APPLICATION NO.	FILING DATE	FIRST NAMED INVENTOR	ATTORNEY DOCKET NO.	CONFIRMATION NO.
10/531,451	04/14/2005	Takashi Kakiuchi	043890-0724	7007

Application No.	Applicant(s)
Office Action Summary	10/531,451	KAKIUCHI, TAKASHI
	Examiner	Art Unit	
	LEONARD J. WEINSTEIN	3746

DETAILED ACTION

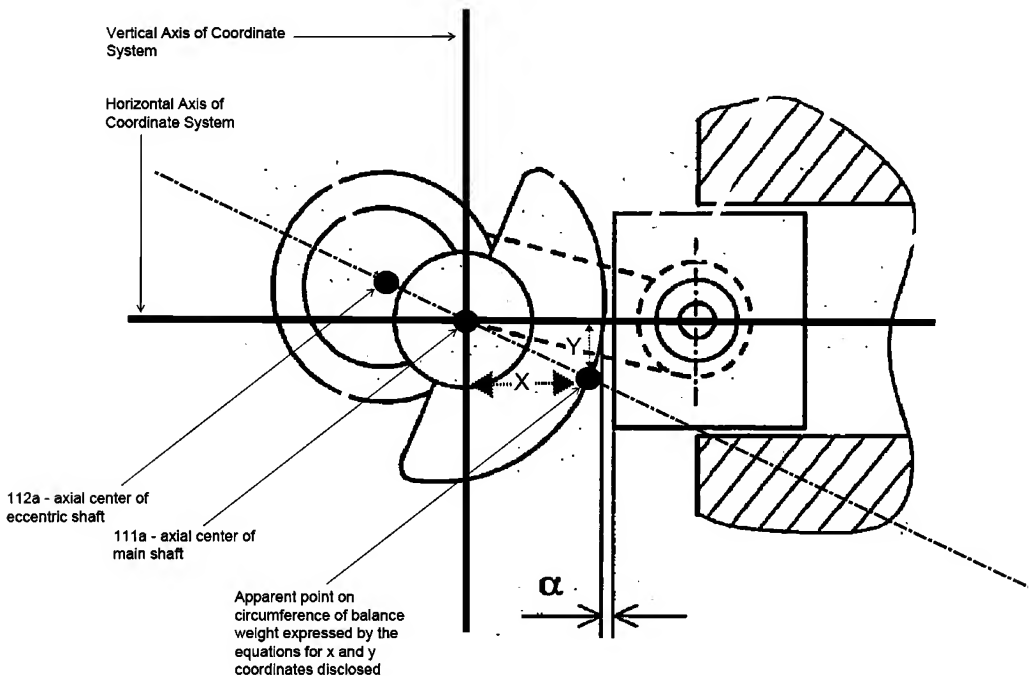
weight's circumference.   The examiner notes that figures 3 and 4 spatially define

all the variables in the equation, but the figures do not show where the point

which is expressed by equations for the x and y coordinates is. One of ordinary

b.   The claims as amended include the limitation that "the portion of the

outer circumference of the balance weight closest to the piston" can be

expressed by the equations listed above. This would mean that the equations

determined the x and y coordinate of different points of a circumference

depending on the rotation angle of the eccentric shaft. This would amount to a

"floating point" on the circumference of the balance weight. The examiner does

not see how this is possible since there is no variable in either equation that is

related to an angular position of any point along the circumference of the balance

weight. The examiner has concluded, though not certain, that the point given by

the equations for x and y, is for the point on the circumference which lies along

the same line that passes through both an axial center 111a of the main shaft

body 111 and an axial center 112a of the eccentric shaft body 112. The examiner

has provided a markup version of figure 3 of the instant application to illustrate

this conclusion. The examiner notes however that any explanation of what point

Apparent point on circumference of balance weight expressed by the equations for x and y coordinates disclosed

on circumference was determined by the equations disclosed would be new
